ABINGTON TOWNSHIP

BOARD OF COMMISSIONERS WORKING SESSION

b. Motion to approve the Preliminary/Final Land Development - LD-22-06 - 2620 West Moreland Road (Raising Cane's).

SHEET NUMBER:
C1.1
2 OF 28

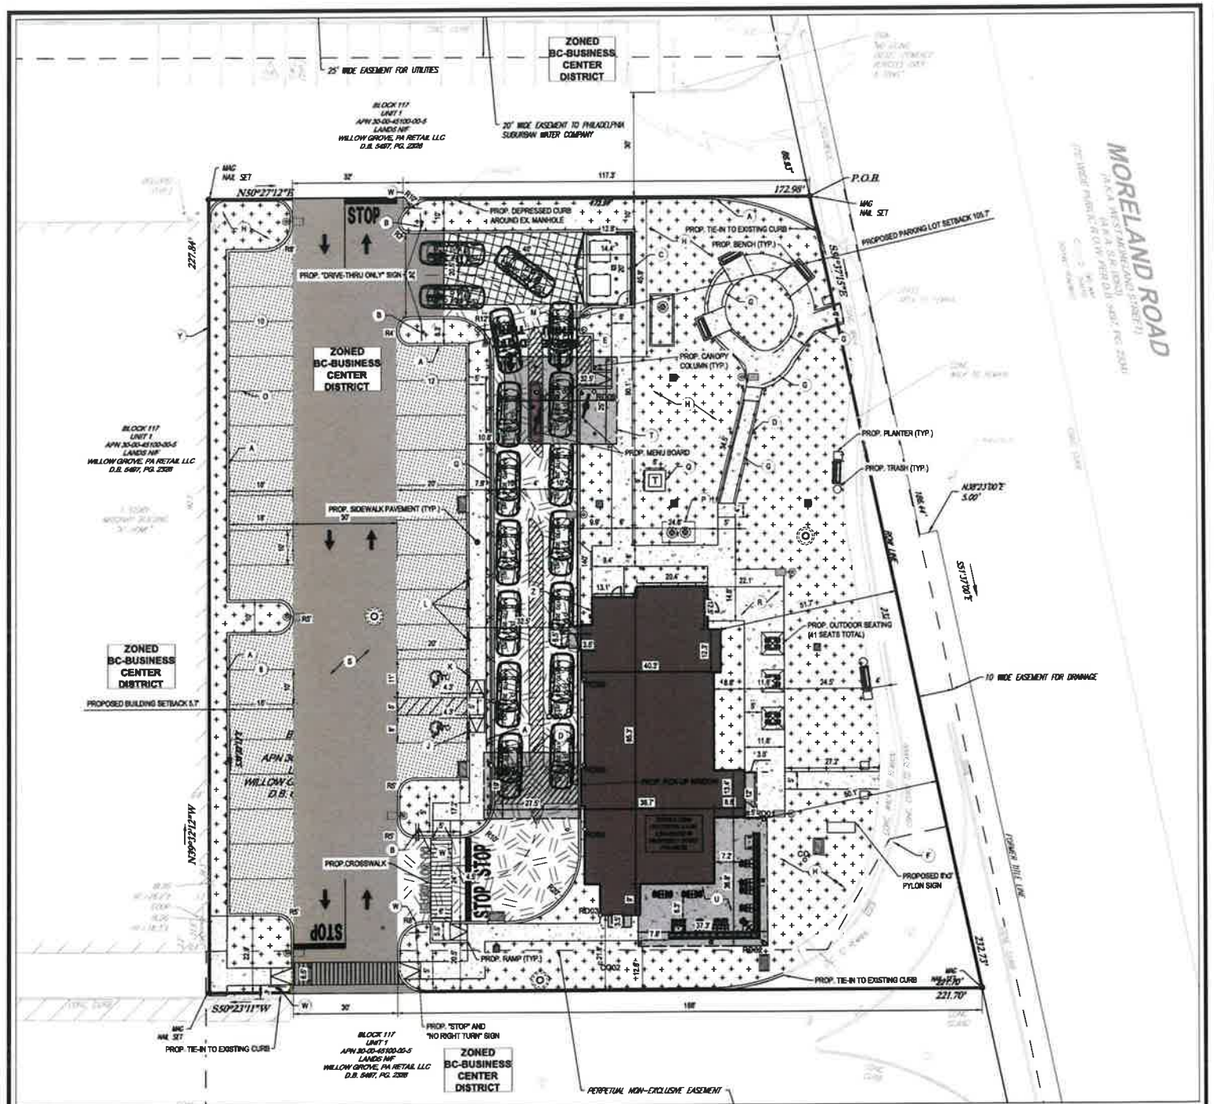
Response: Parking has been revised to match Abington Township dimension standards. Please see Sheet C1.1.

Response: Table has been revised to show the corrected height of 20’. Please see Sheet C1.1.

Response: A crosswalk, designed to Abington Standards, has been implemented at the drive access. Please see Sheet C1.1.

Response: The outdoor tables are fixed to the ground, and the chairs will be secured after normal operating hours. A note has been added to sheet C1.1.

Response: A note has been added to sheet C1.1.

Response: The zoning chart on the Record Plan C1.1 is revised to list the Parking Use requirements A-17.

Response: The zoning chart on the Record Plan C1.1 is revised to list the Parking Use requirements C-25.

Response: Parking Spaces have been revised to meet 146-28.A parking requirements. See Sheet C1.1. Parking spaces adjacent to building shown as 10' by 20'. Parking spaces to the west of the drive aisle shown as 10' by 18' due to the 2' overhang in the landscape area.

SHEET NUMBER:
C4.0
8 OF 26

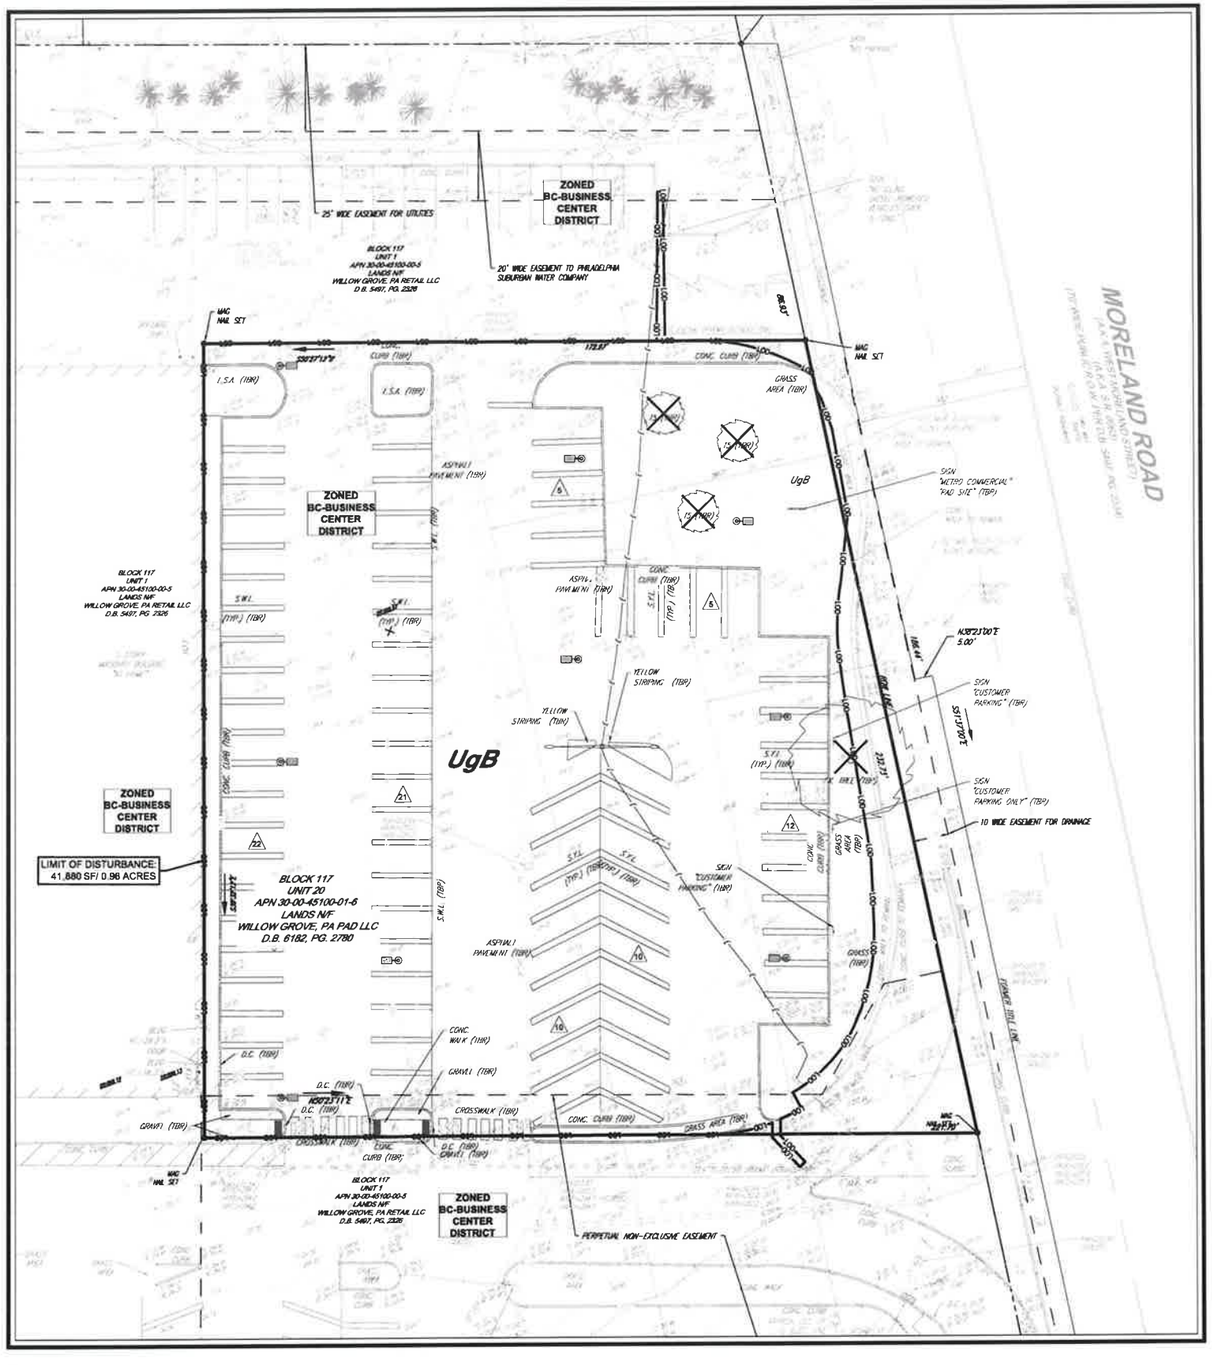
39. Per §146-11.B.(8).(b) & §146-11.D.(4) – Existing Features Plan & Grading Plan – The existing features plan shall contain the datum to which contour lines refer. This note shall be provided on the Existing Conditions plan (Sheet C4.0) and grading plan (Sheet C6.0) per Section 146-11.D.(4).

Response: Note stating "Existing Contour Information are based on the NAVD88 Datum" has been added to Sheets C4.0 and C6.0.

Response: Soil Map and Soil Limitations and Their Resolutions have been provided on Sheet C3.1 due to spacing on Sheet C4.0 (Existing Features Plan). Note added to the C4.0 stating the Soil Type and referring to C3.1 for Limitation Notes.

SHEET NUMBER:
C7.0
17 OF 26

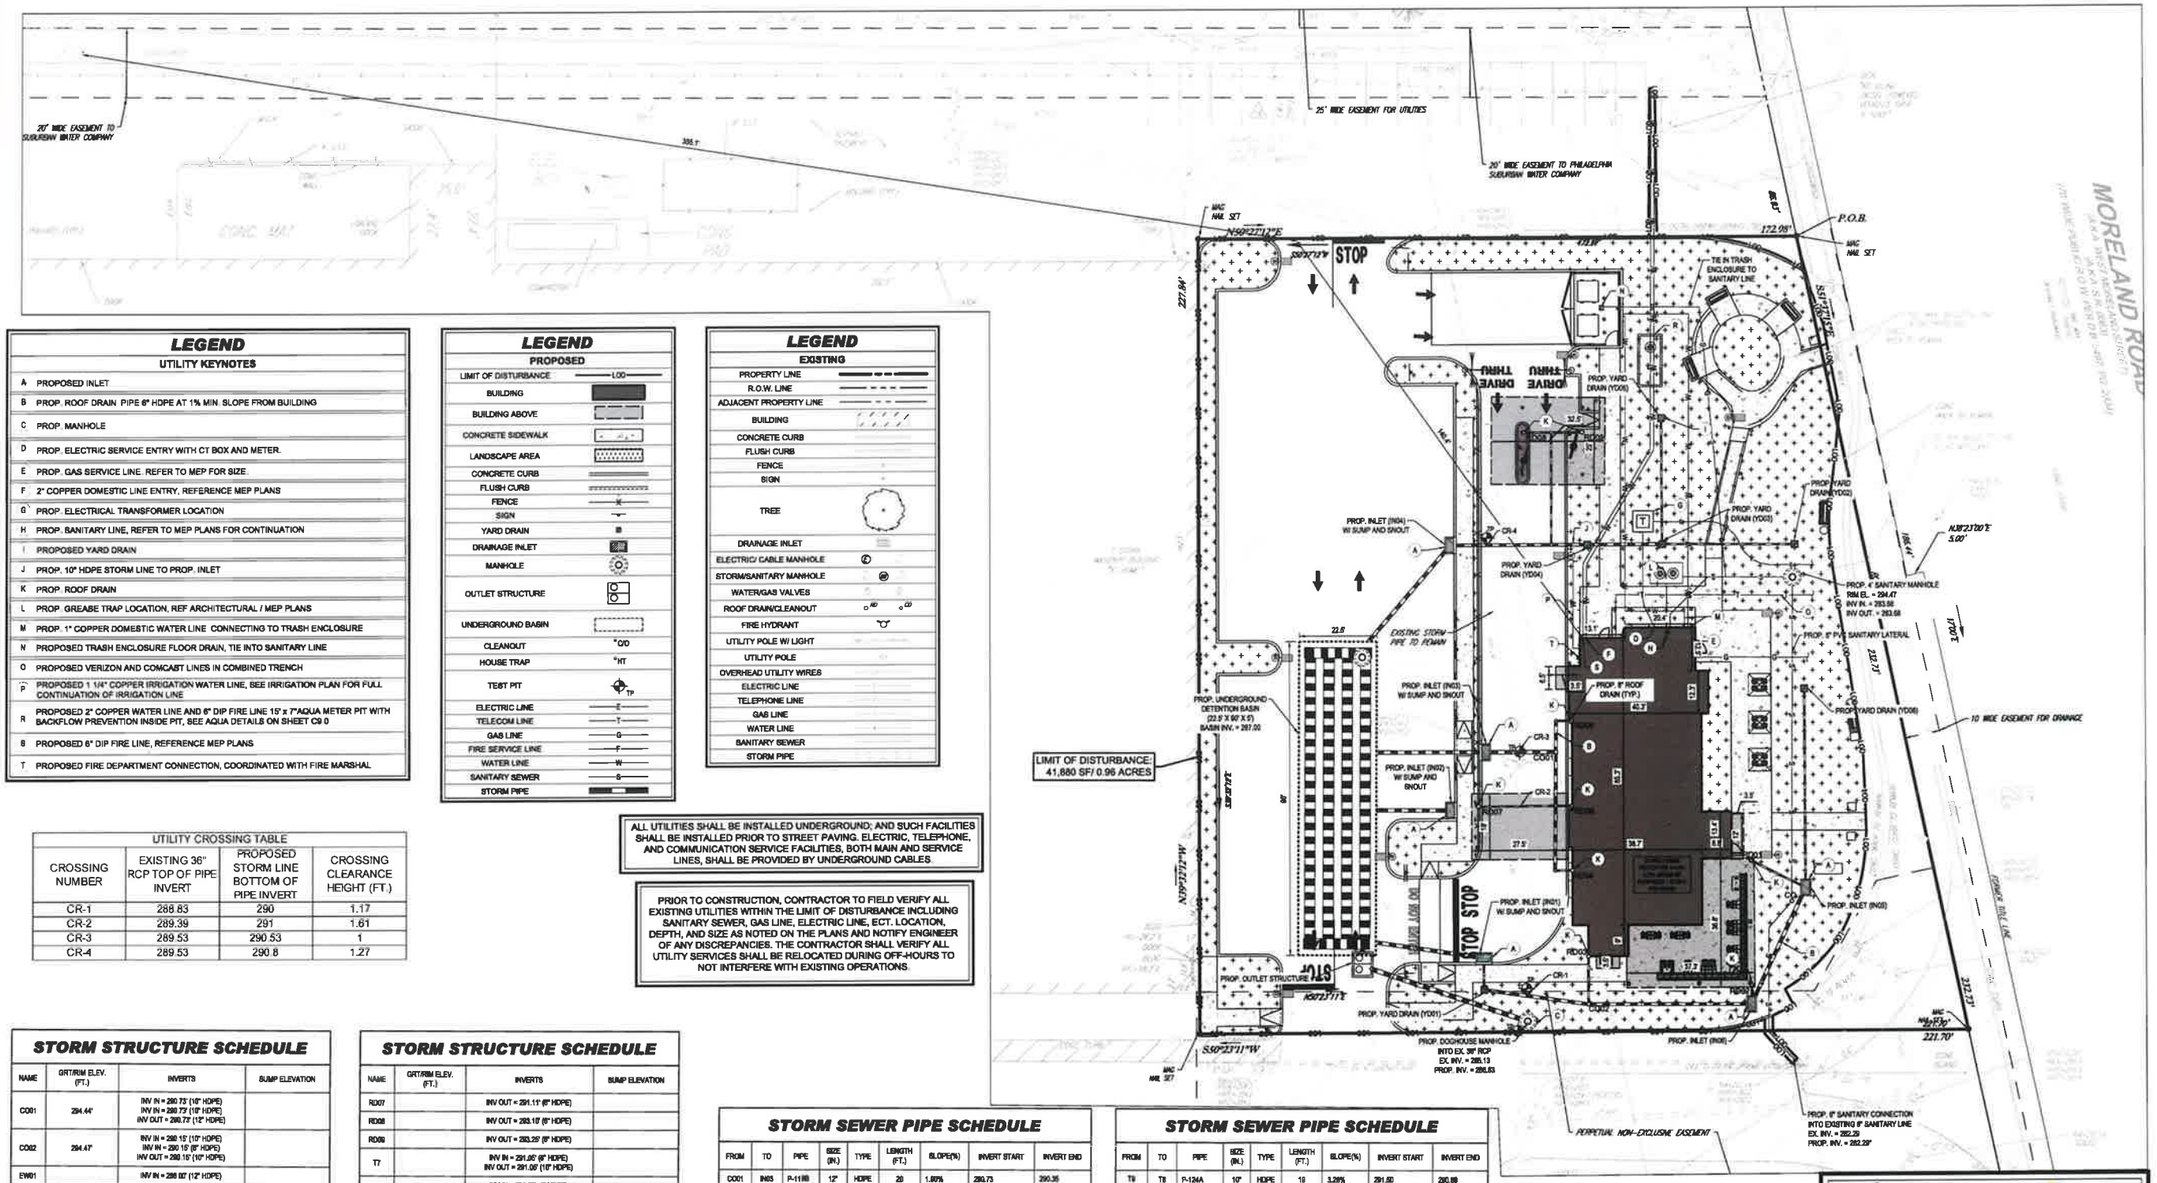
5. Would the applicant clarify drainage for the trash enclosure area for the restaurant? On sheet C7, Utility Plan, the legend indicates that the trash enclosure floor drain ties into the storm sewer system, but the plan indicates tie-in to Sanitary Sewer. We recommend that this be tied to Sanitary Sewer line to capture any pollutants that might run off from trash enclosure areas, especially since this area is not covered.

Response: This was a typo, the Trash enclosure floor drain is to tie into the sanitary sewer. Please see Sheet C7-0.

Response: Please see Sheet C7.0, which has been revised to show an existing Fire Hydrant located within 500' of the building. Proposed Fire Department Connection shown on plan with label "T".

Response: Note has been added to Sheet C7.0.

SHEET NUMBER:
C10.0
23 OF 26

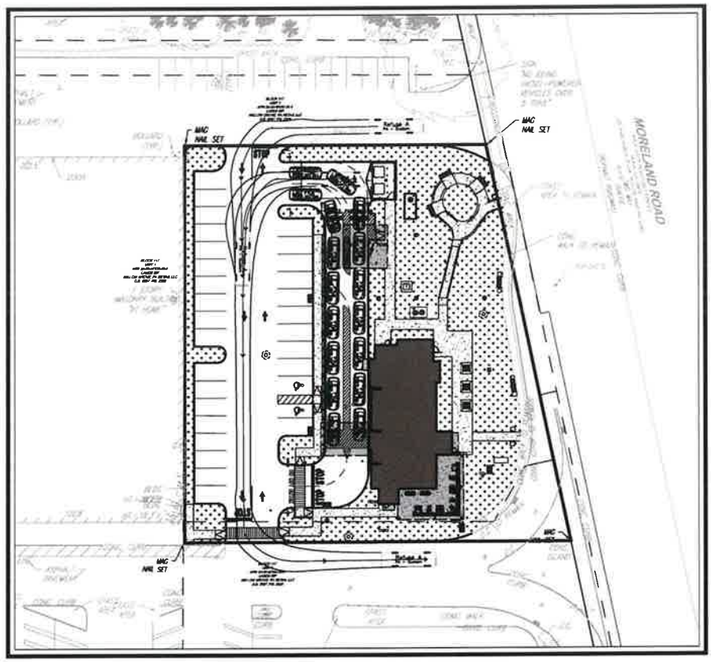
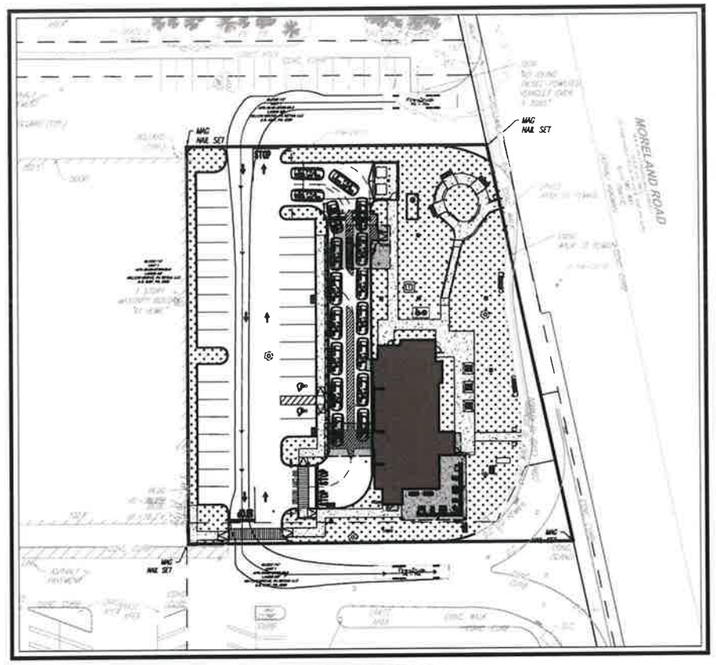
18. Per §2312.A thru K – Off-Street Loading Requirements – There is no loading berth/area shown on the plans. Since the proposed fast-food restaurant will be receiving deliveries of food and supplies to the site, a loading berth/area shall be provided. The plans shall indicate where the loading berth/area will be provided on the site. The loading berth/area shall adhere to the requirements of this Code Section. Per Figure 23.2, the fast-food restaurant is classified as an other use and is required to have 1 loading berth/area for the first 20,000 SF of gross floor area.

Response: Raising Cane's deliveries will occur during off hours when the store is closed, therefore a dedicated loading space is not needed. Refer to Vehicle circulation plan, Sheet C-10 showing the delivery truck movement as well as a note indicating "deliveries to occur during off hours when store is closed".

2 A4.10 FRONT ENTRY ELEVATION
SCALE: 1/4" = 1'-0"

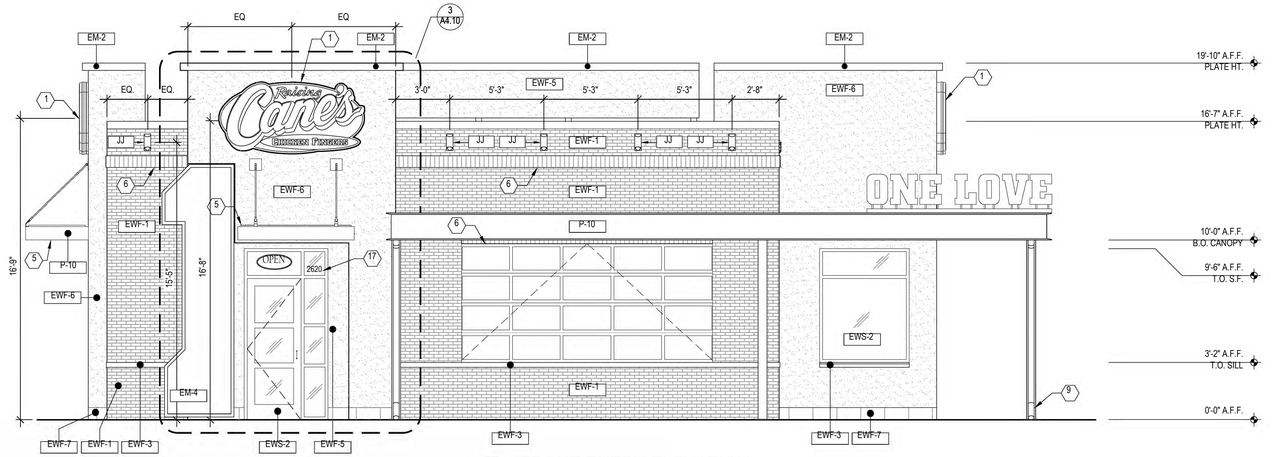
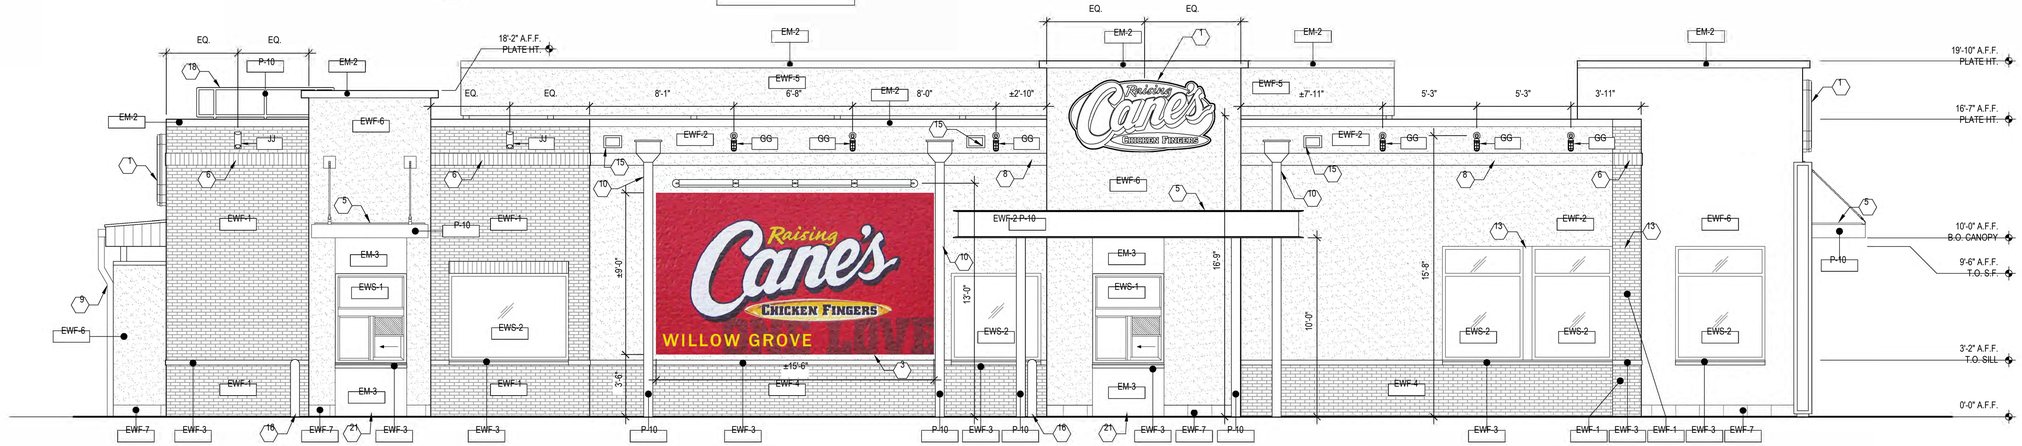
3. Per §1103 Figure 11.9 – Dimensional Regulations – The minimum façade height shall be 20 feet, or 25 feet if a pitched roof. Per the architectural plans, a façade height of 19.8 feet is proposed for the Raising Cane's restaurant which is less than the 20 feet minimum requirement. The façade height shall be revised to conform with the 20 feet minimum requirement; otherwise, a variance from this Code Section will be required.

Response: Confirmed. The rooftop HVAC and mechanical equipment is screened from public view as shown on sheet A4.10
